Appendix F

**AGENCY CONSULTATION**

RE: Sultan River Project  
Anadromous Fish Study - Powerhouse Ramping Rate

Jackson (Sultan River) Project - FERC #2157  
Anadromous Fish Mitigation Study  
Powerhouse Downramping Rates - Revised Study Report

# Fry Stranding Test Schedule

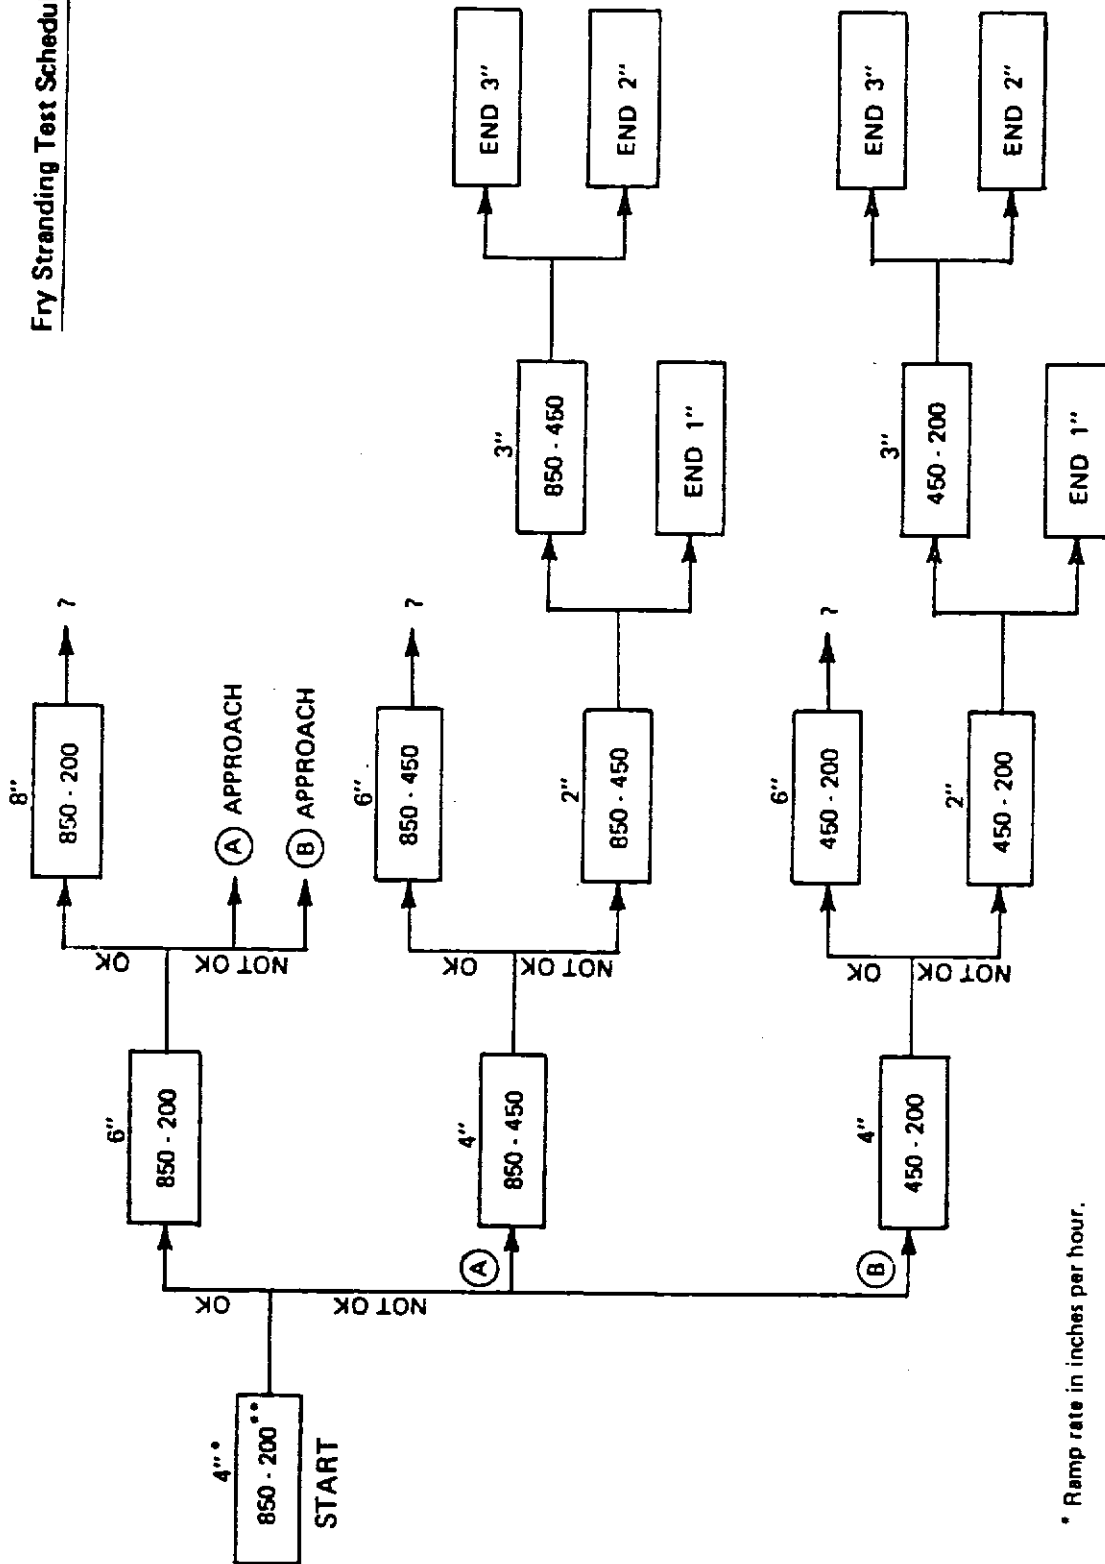
Phase 2 will consist of the actual testing of variable ramp rates when salmon and/or steelhead fry are present. The step-by-step testing approach (see attached figure) is conservative to minimize fry mortalities. This schedule assumes that a critical flow range is identified during Phase 1 (850 to 200 cfs assumed for illustrative purposes).

Figure 1  
MINIMUM FLOW AT GAUGING STATIONS

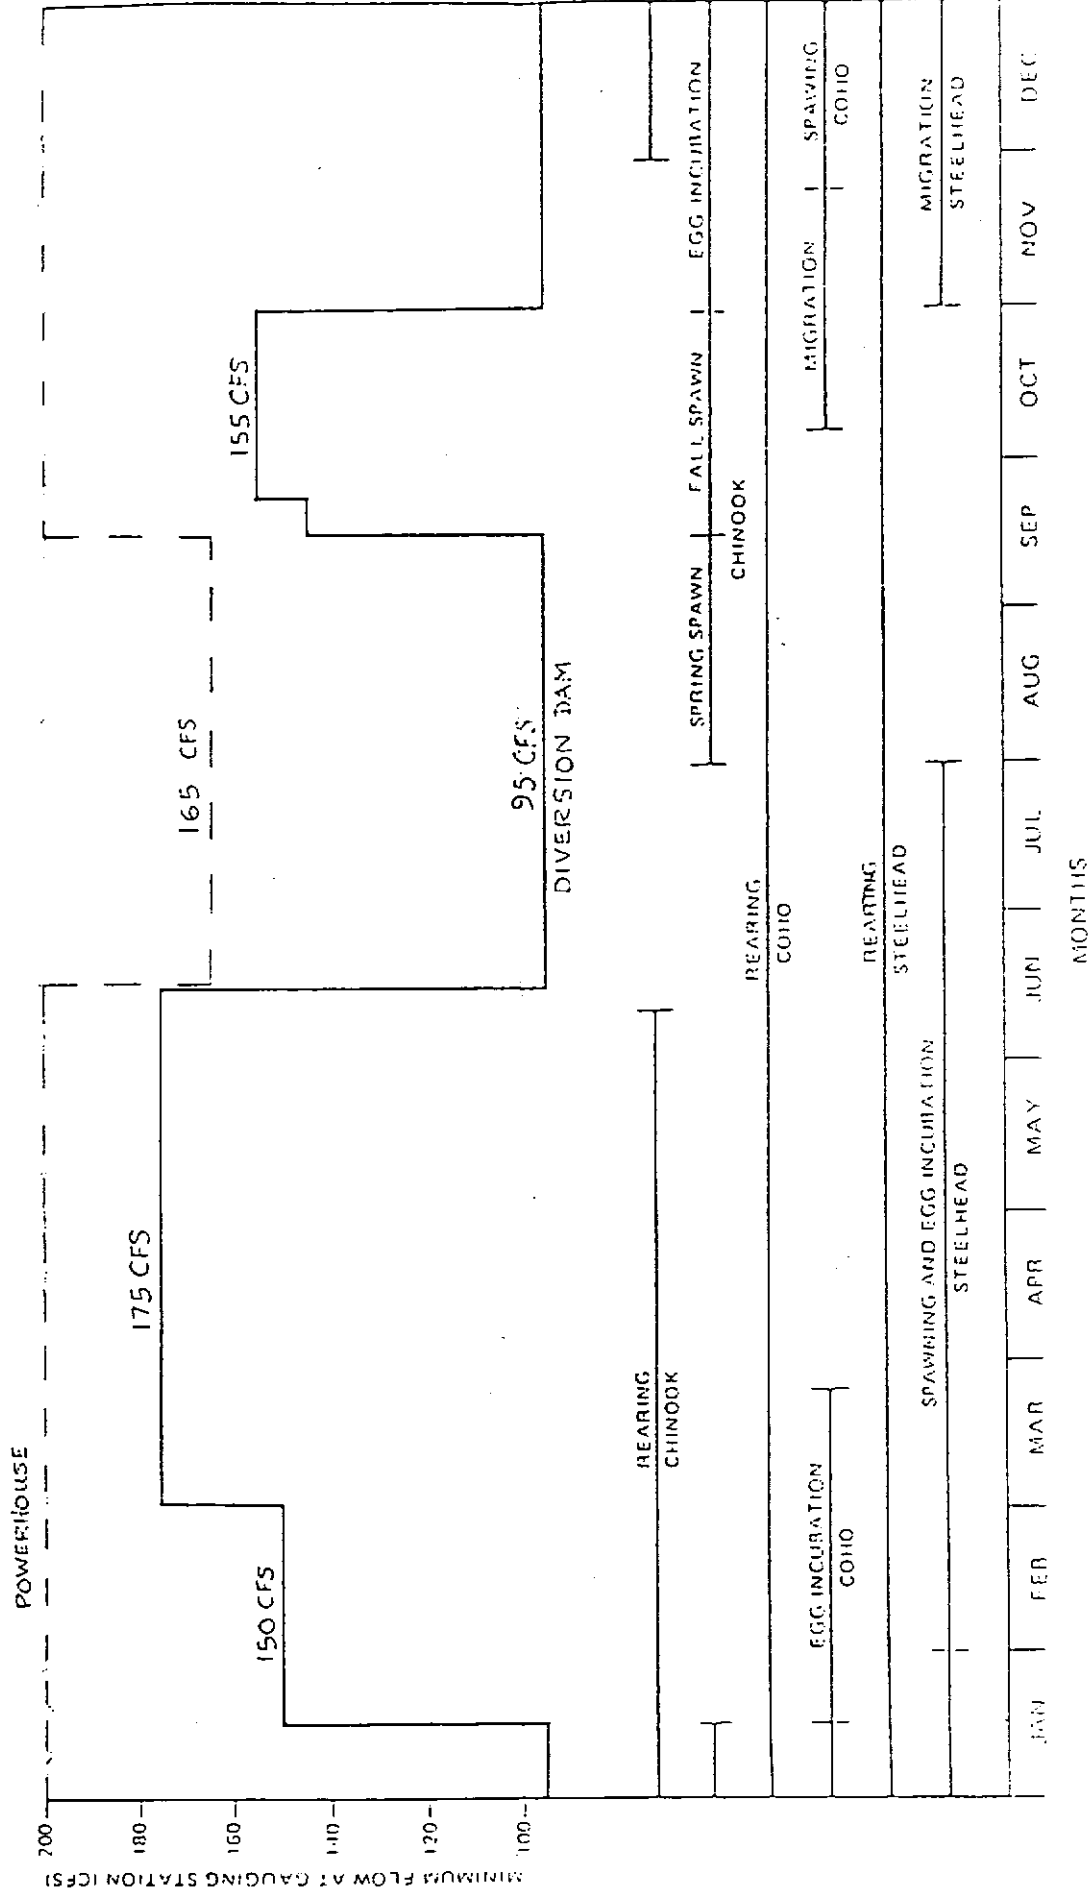
5. Specific Comments
6. Figure 1, Life History Information, Page 4. As discussed on the phone, reacting chinook may be in the river any time of the year, chinook incubation can be extended through May.

5. Figure 1 was copied from an earlier project document and revised to reflect the in-stream minimum flow schedule in the Settlement Agreement (Section 2). The figure has been revised again in accord with WDF's comments.

FIGURE 3  
 REVISED FIGURE H-3  
 RULE CURVES FOR RESERVOIR OPERATION - SPADA LAKE

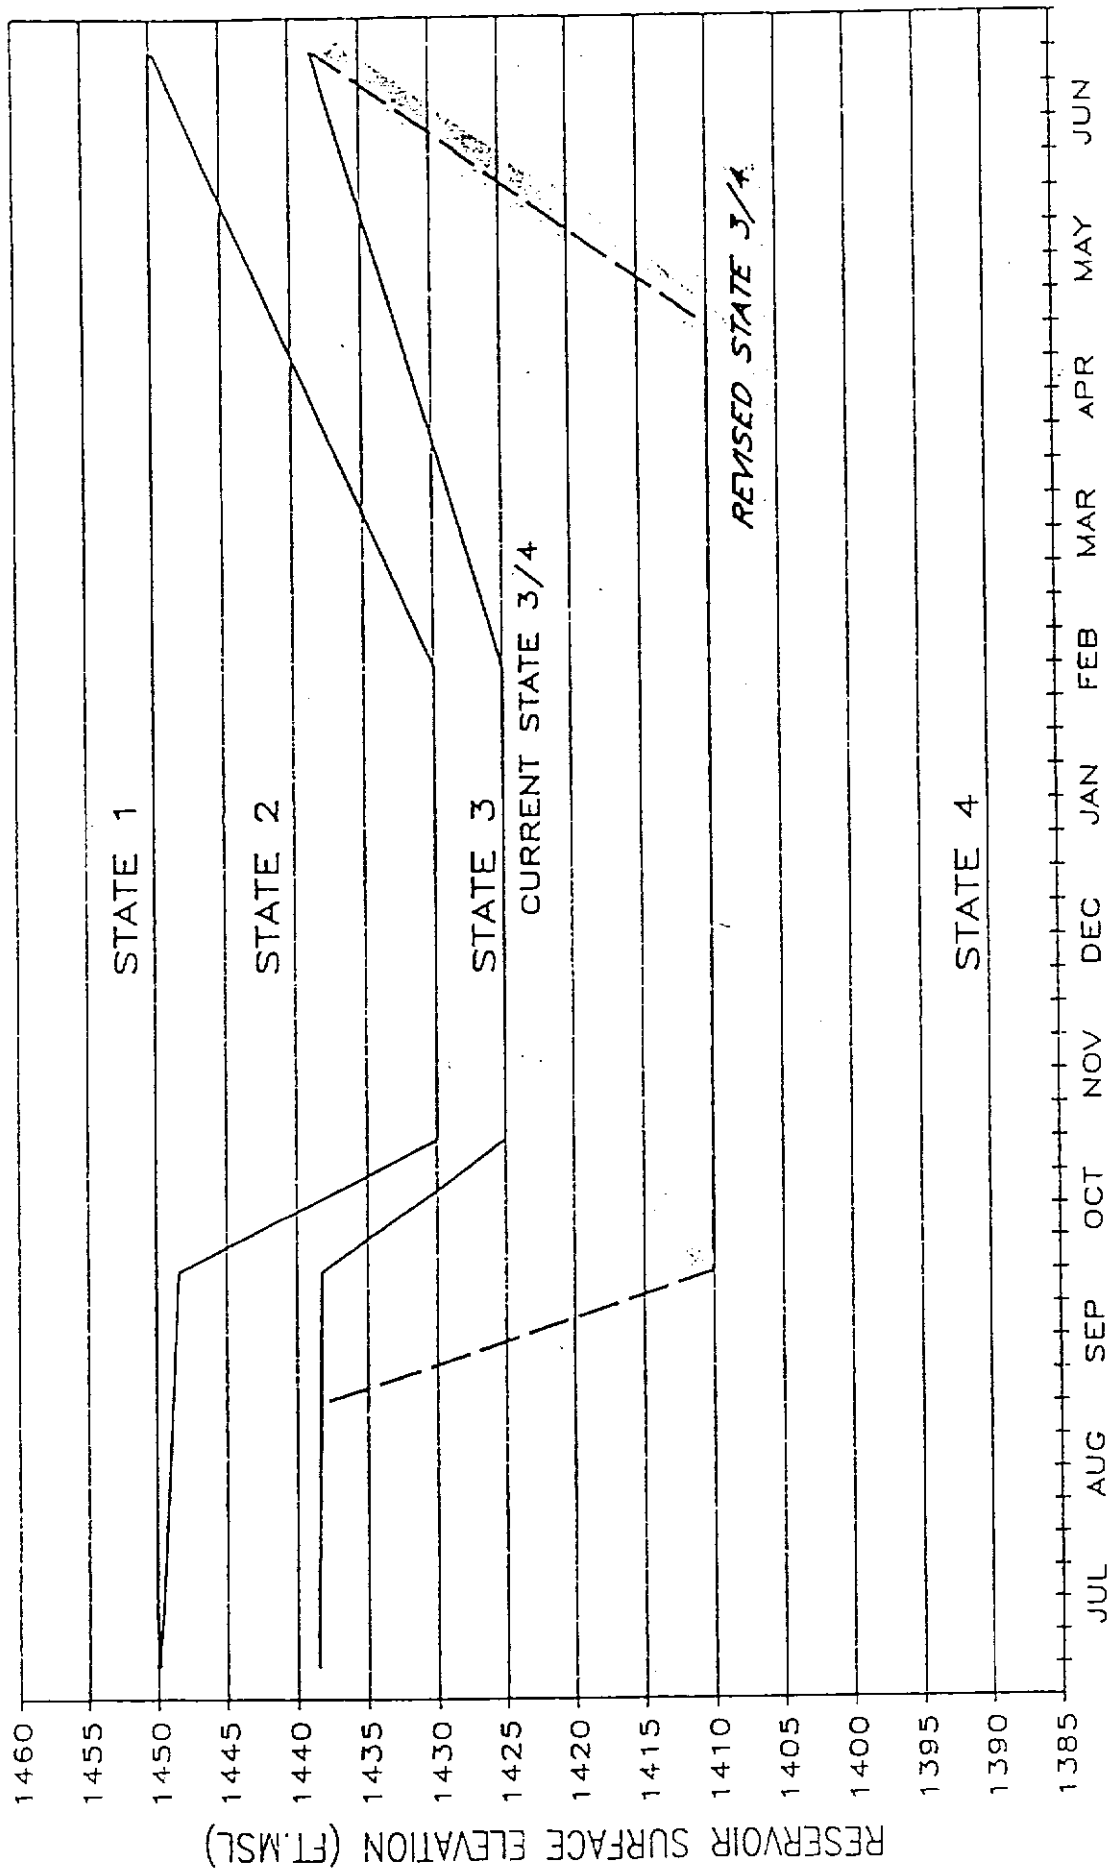
Metzgar asked Crocker to discuss what the effect of the difference between Figures H-3 and H-3 (revised) would be on the fluctuations in Table 2 for February, 1989, during the record-breaking cold weather/electric load/demand. Crocker responded that the river flow changes or the range of fluctuation would have been smaller, only down to 700-750 cfs on a daily basis rather than lower as occurred this year. Thus, there would probably have been less number ones (downs).

Figure H-3 on page H-16 is replaced with Figure H-3 (revised), which is Figure 3 herein. The Joint Agencies and Licensee agree that the operating criteria for release of water from Spada Lake in order of priority are:
